BRISTOL, VIRGINIA INTEGRATED SOLID WASTE MANAGEMENT FACILITY

STAGE II LANDFILL GAS COLLECTION AND CONTROL SYSTEM EXPANSION

CONSTRUCTION PLANS

FEBRUARY 18, 2025
ADDENDUM 1: APRIL 7, 2025

DRAWING NO. E6

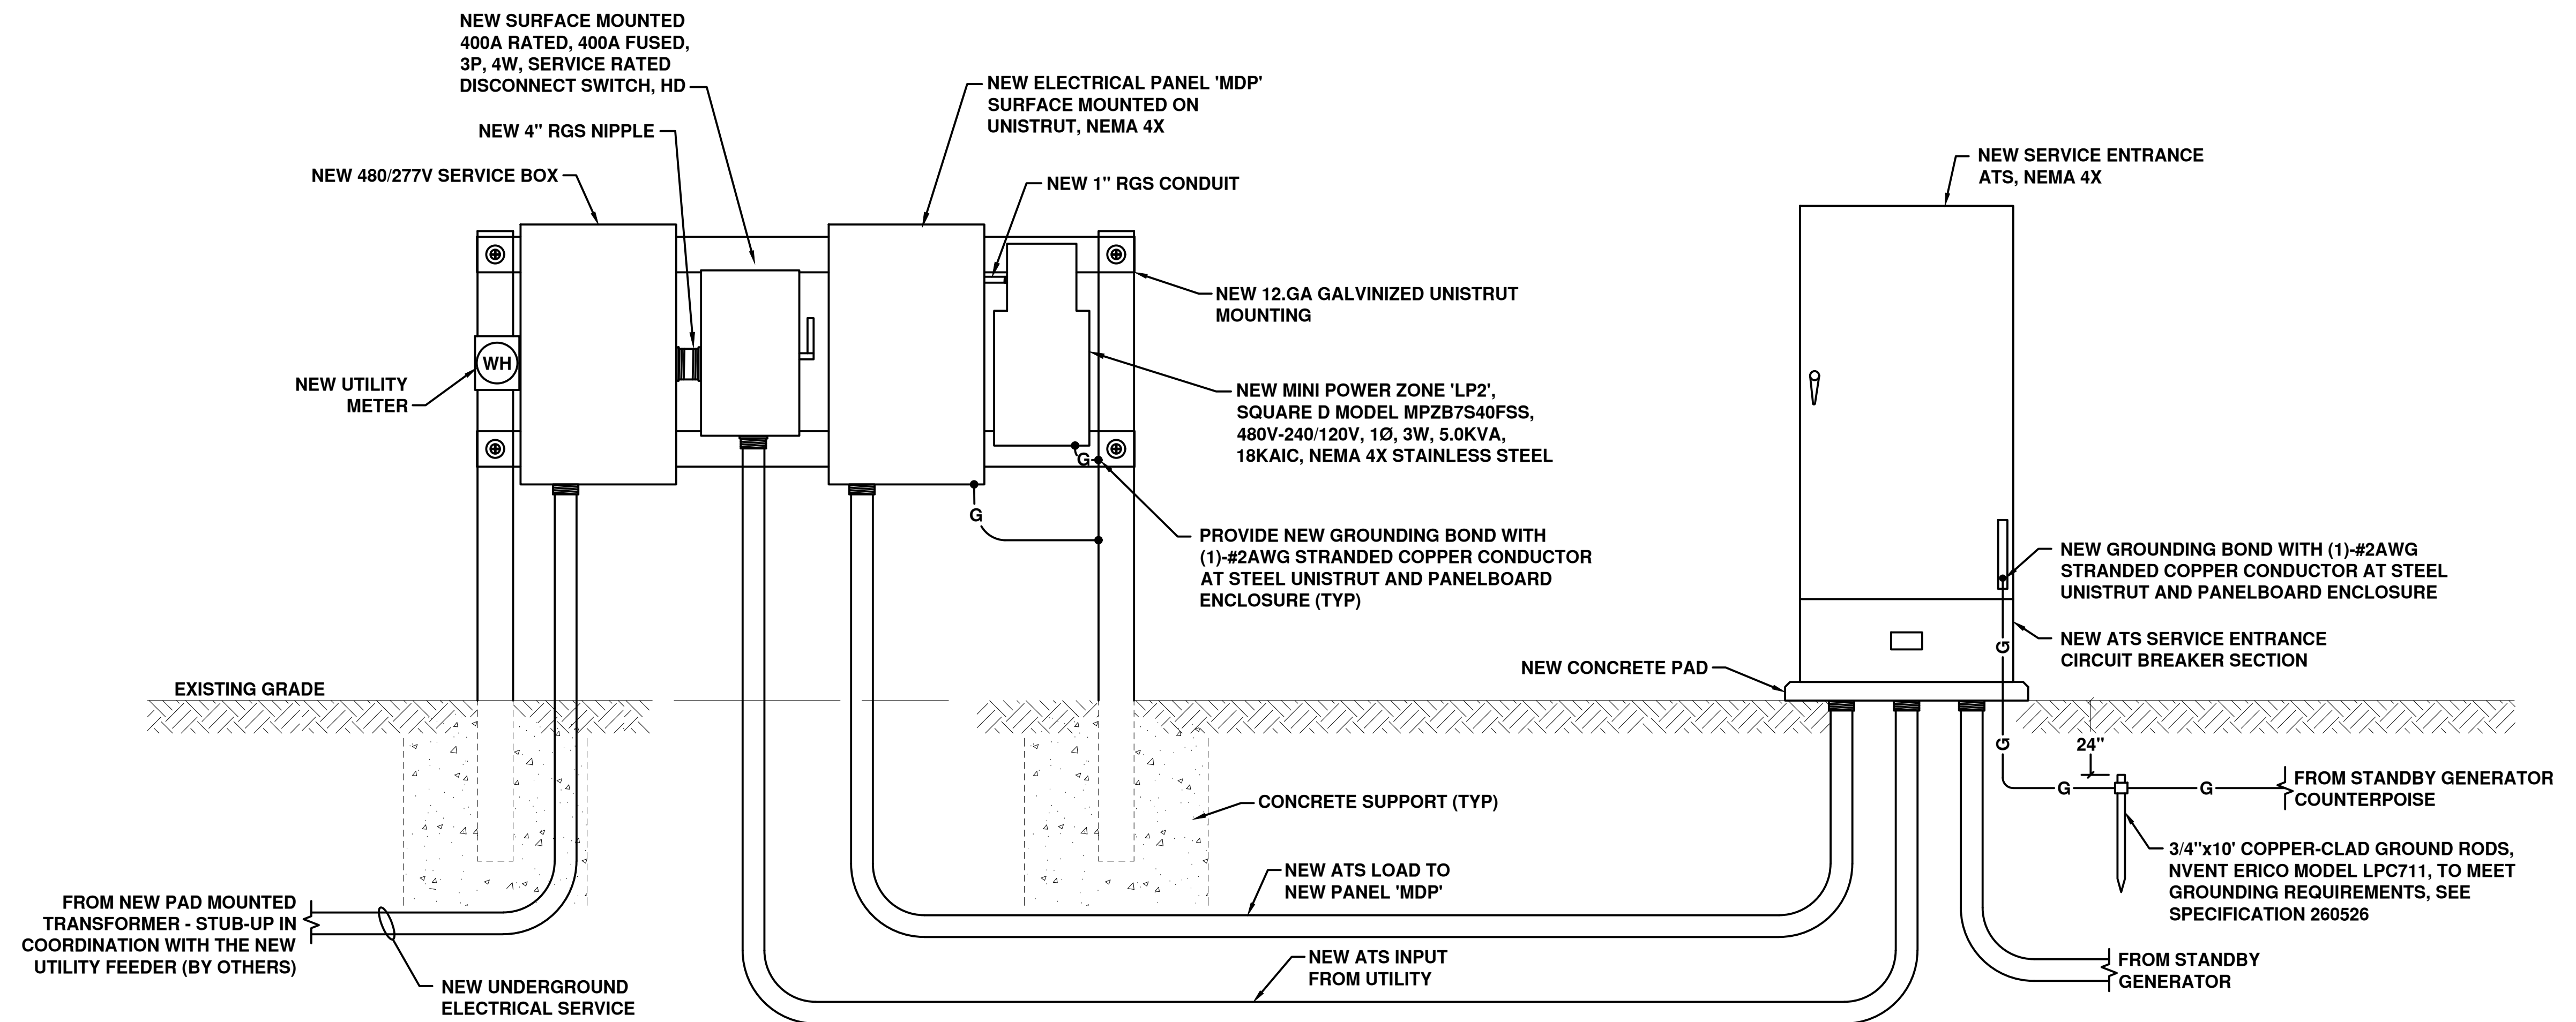
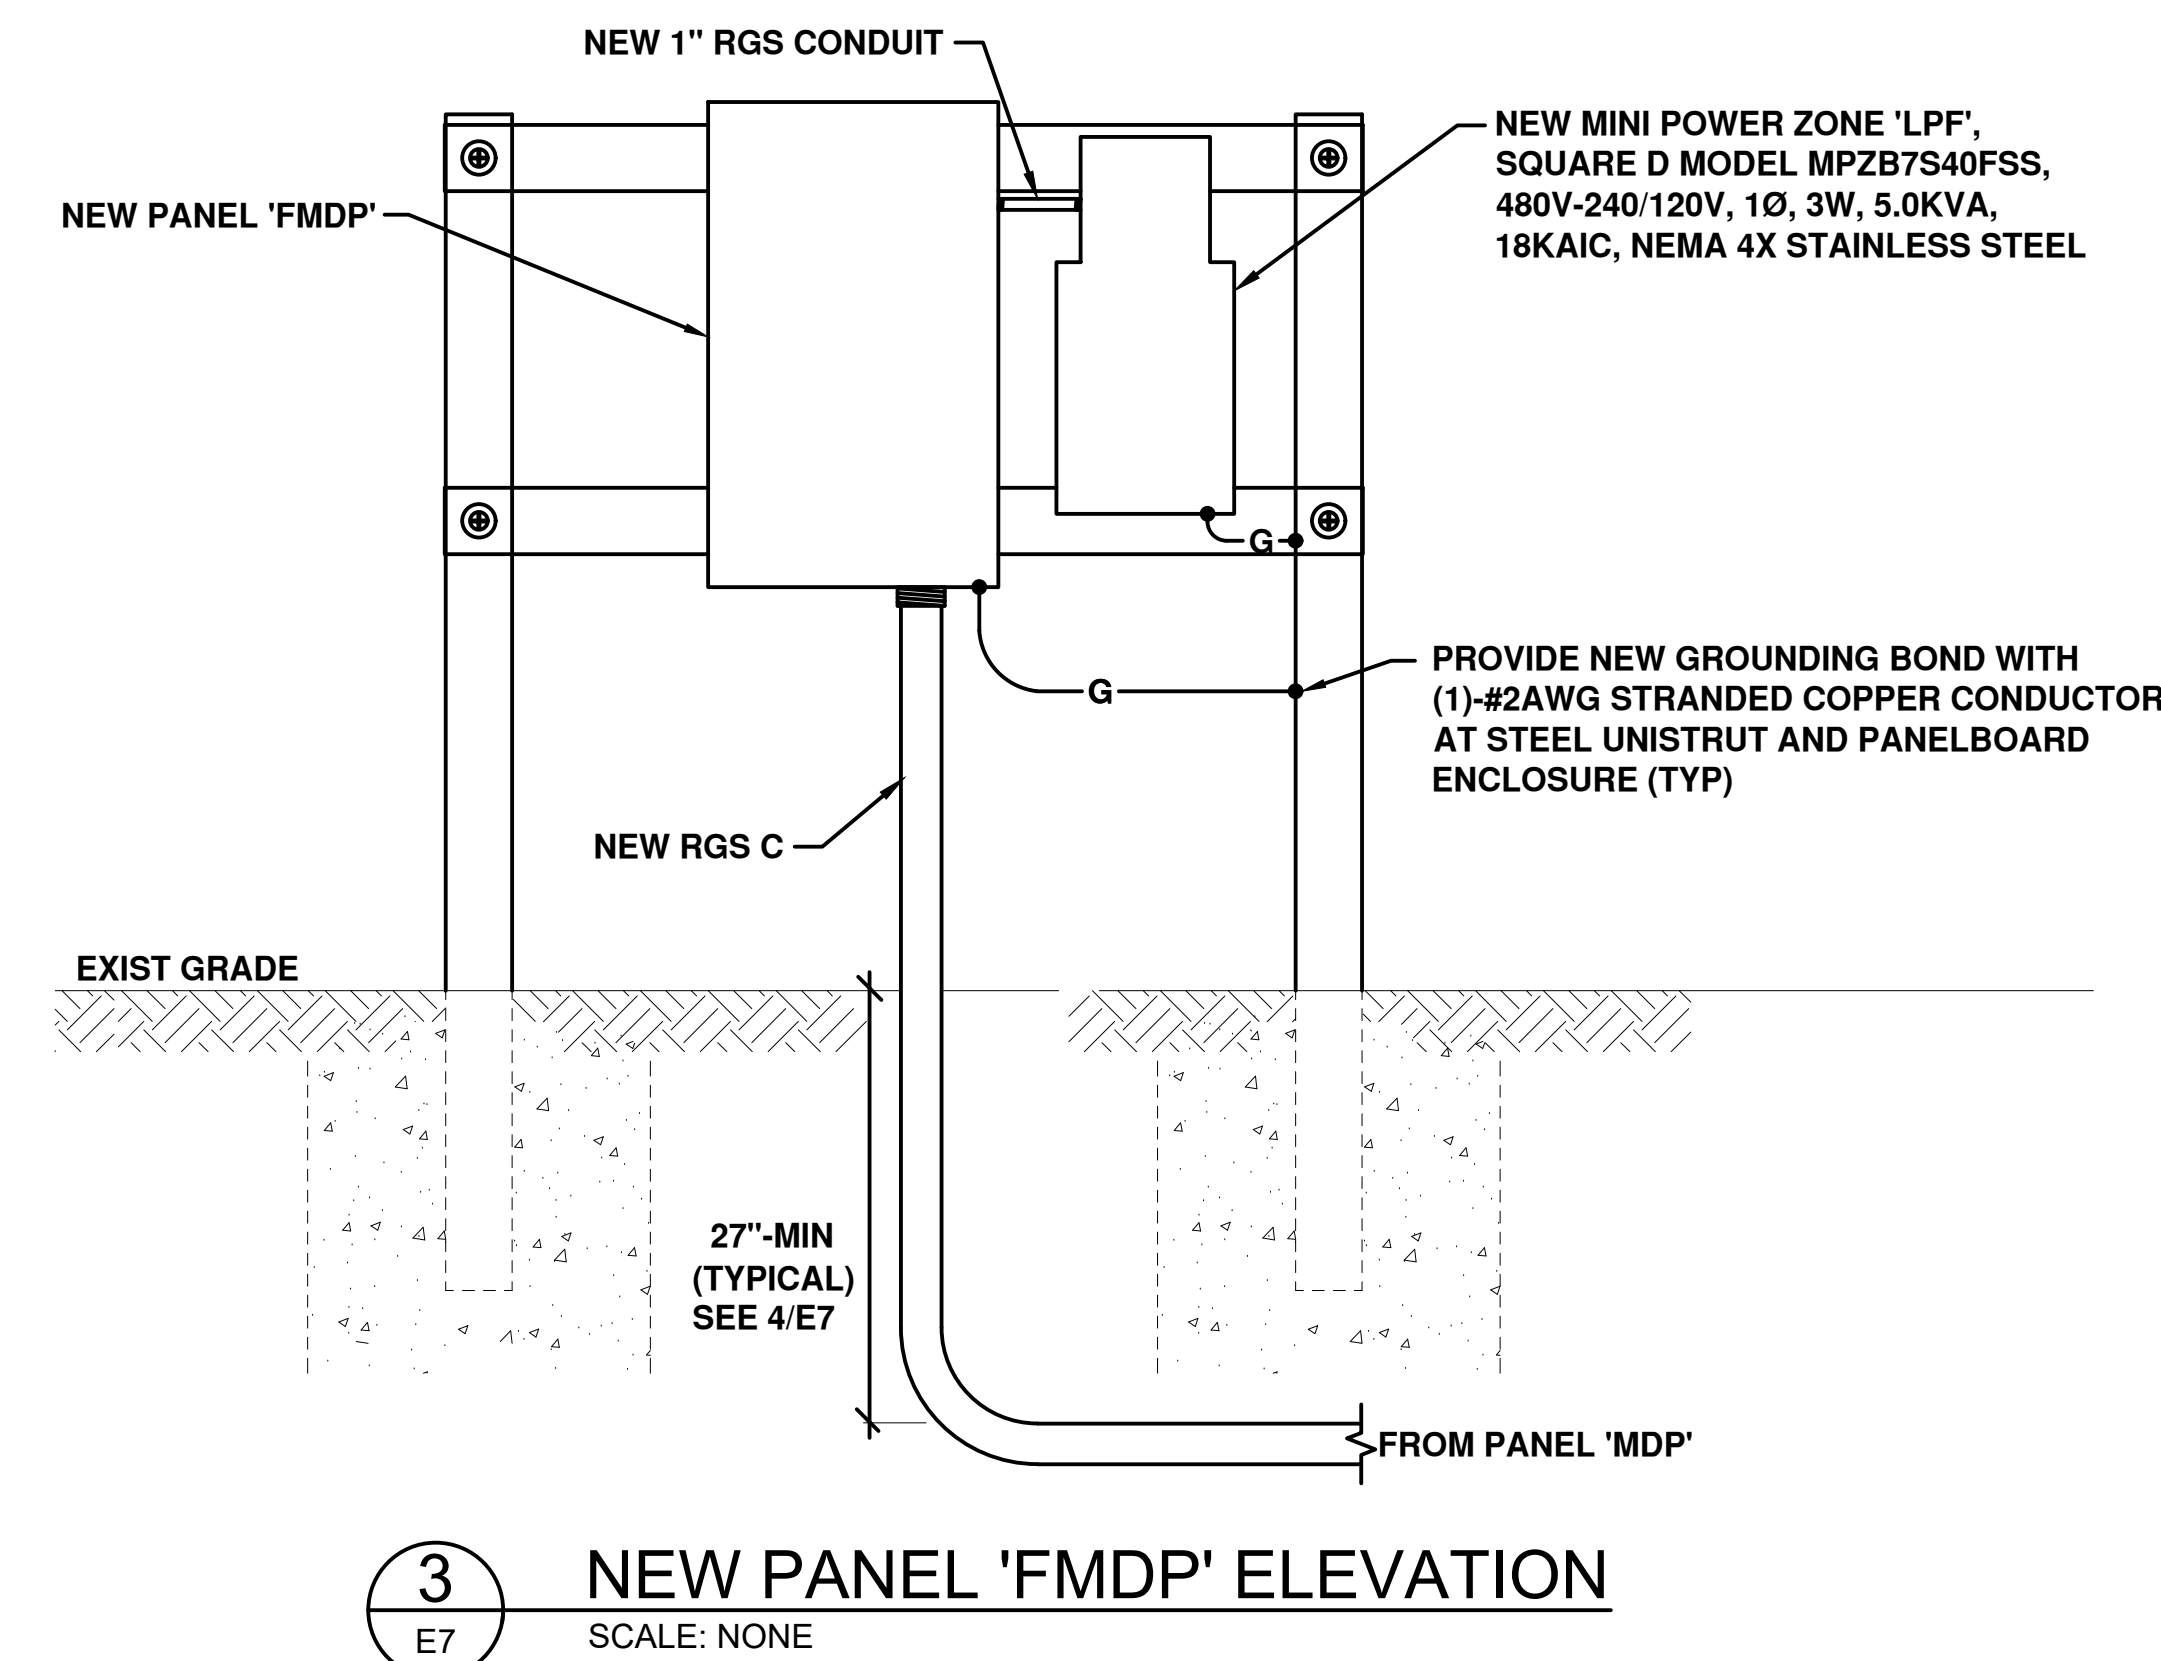
SCS ENGINEERS COMMENT 02/13/25:
DETAIL 6 ON SHEET E7 WILL NOT BE
USED FOR THE STAGE II LFGCCS
EXPANSION PROJECT.
